Re: Response to Submissions - Integra Mine Complex Modification 1 Environmental Assessment

Table 1 Response to submissions on Integra Mine Complex Modification 1 EA

Amended Figure 3.1 - Complex Overview

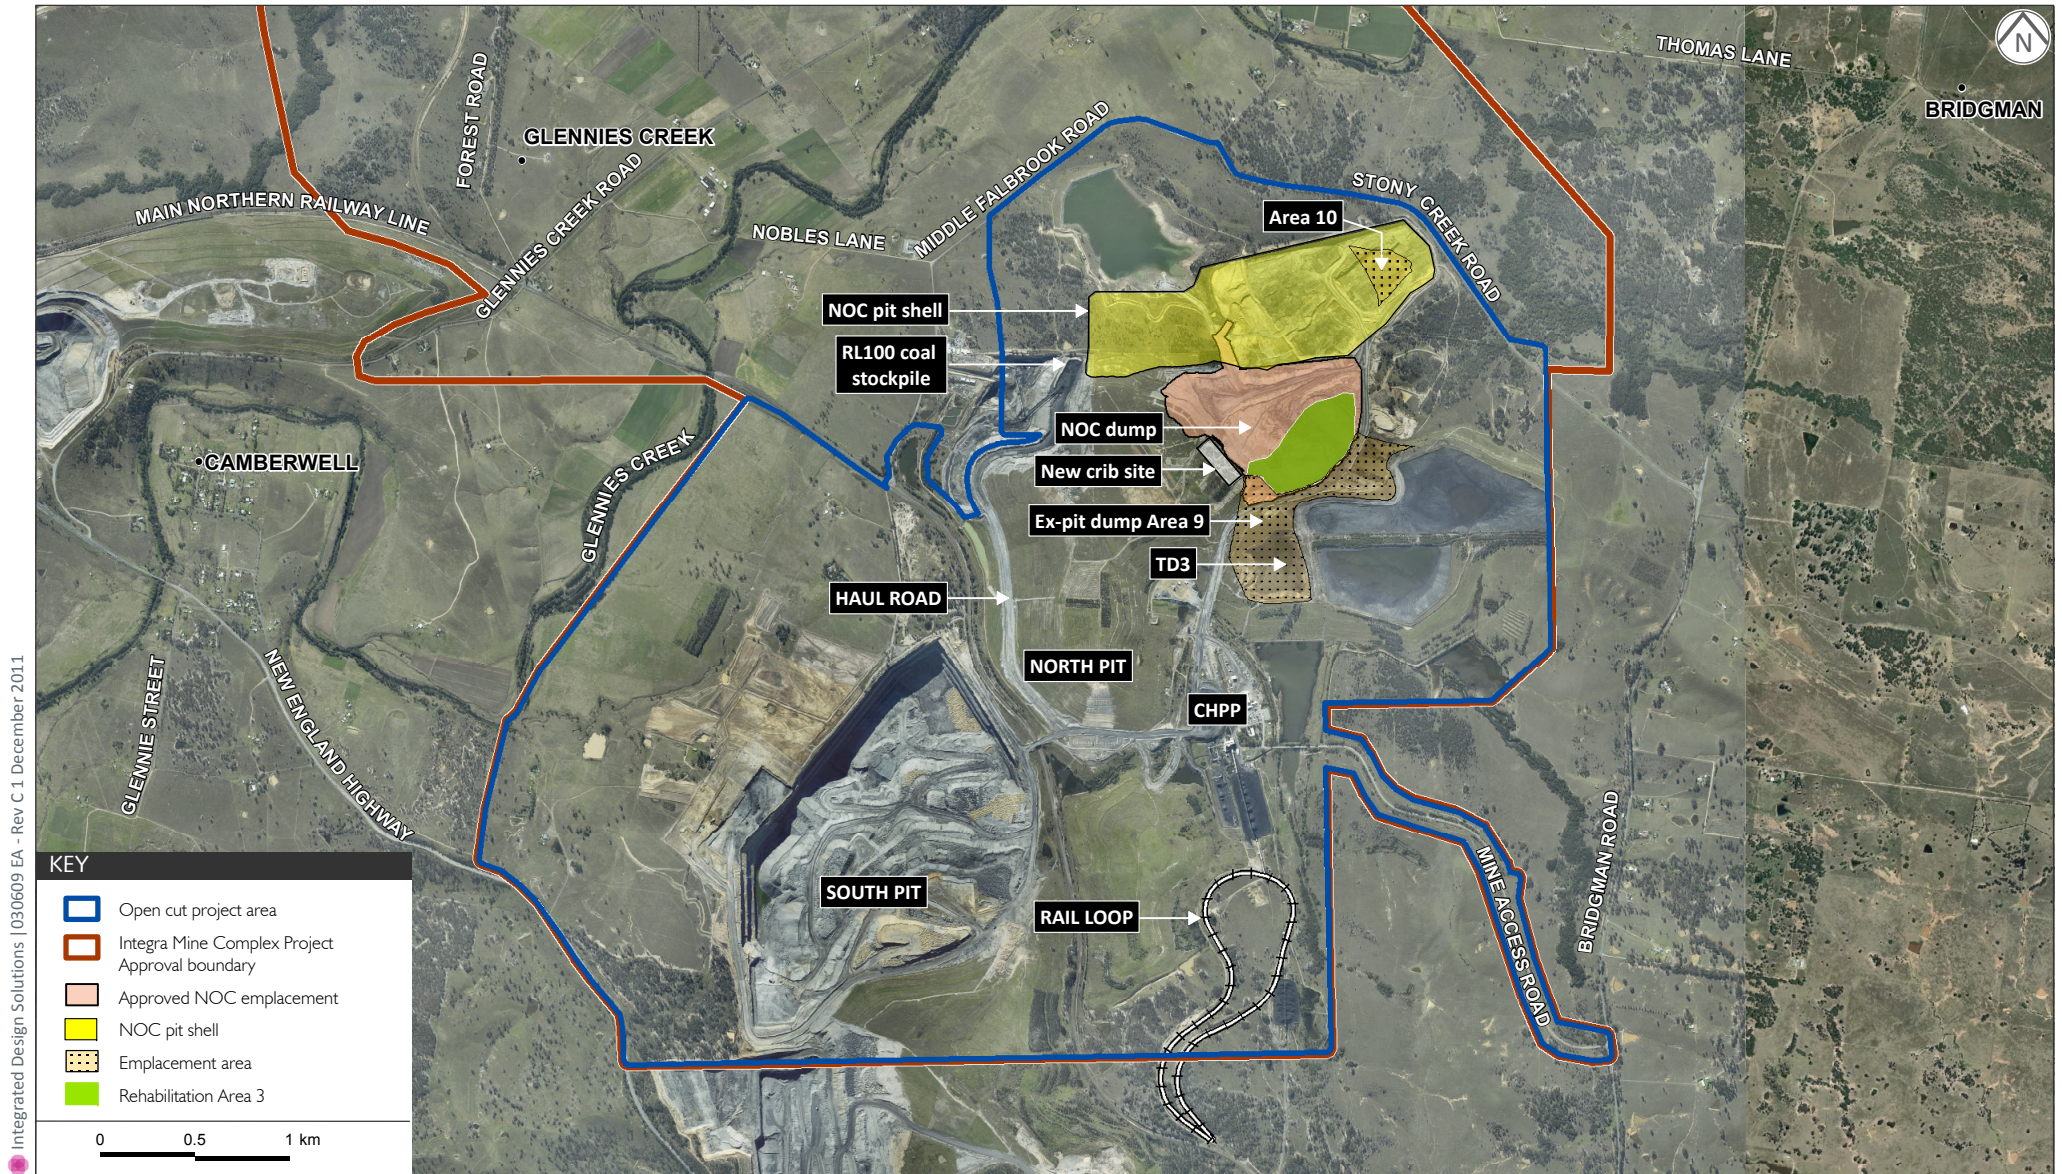
Subject to the above, NOW does not oppose the modification.	Noted.
DRE	
DRE supports approval of the modifications sought by Integra.	Noted.
Section 3.1 of the EA incorrectly states that the currently approved Mine Operation Plan allows for out-of-pit emplacement to 145 m AHD.	Noted.
CFMEU	
Considers that on balance the overall potential impacts of the modification are consistent with the project approvals and objectives of the EP&A Act and therefore supports the application.	Noted.
EPA	
EPA does not support modification application or extension of time for biodiversity offset strategy.	Noted.
It appears that the northern section of ex-pit dump Area 9 overlaps the southern portion of the Southern Biodiversity Offset Area. If encroachment by ex-pit Area 9 is proposed Vale will need to identify measures to be employed to prevent impact on the Southern Biodiversity Offset Area.	Ex-pit dump Area 9 as indicated within Figure 3.1 from the Integra Mine Complex Modification 1 Environmental Assessment has been revised by reducing the extent of dumping and no longer proposes to overlap the southern limit of the Southern Biodiversity Offset area. The environmental impact of reducing the extent of Area 9 is considered to be negligible. Please see attached updated figure.
